BACKWALL REPAIR DETAIL

LAKE COUNTY
LAK-44-202
CHANGE ORDER

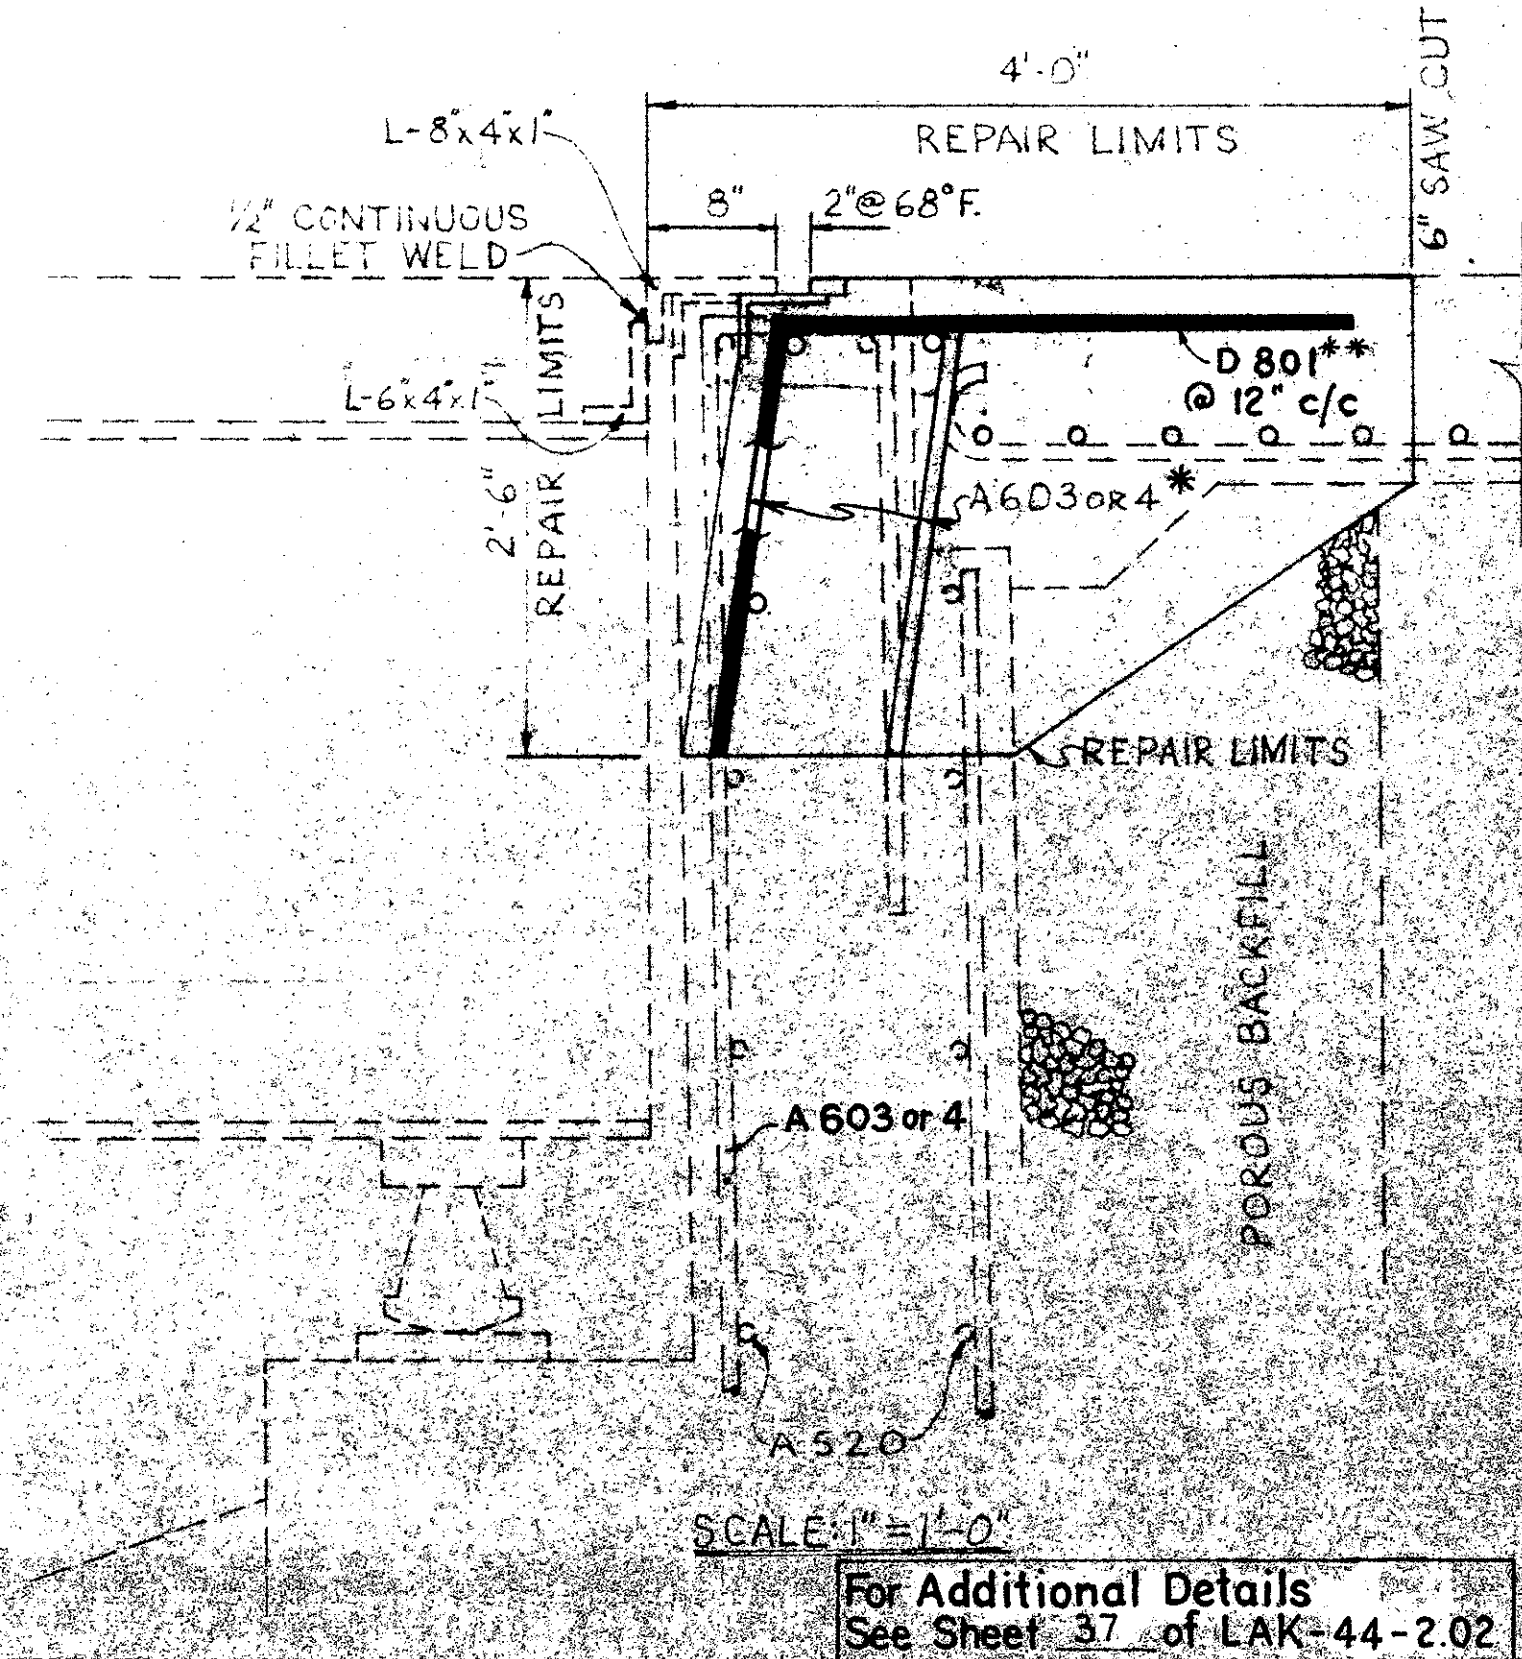
- * Bend existing A 603 or 4 bars, as shown
- ** Add D 801 Bars next to A 603 or 4.
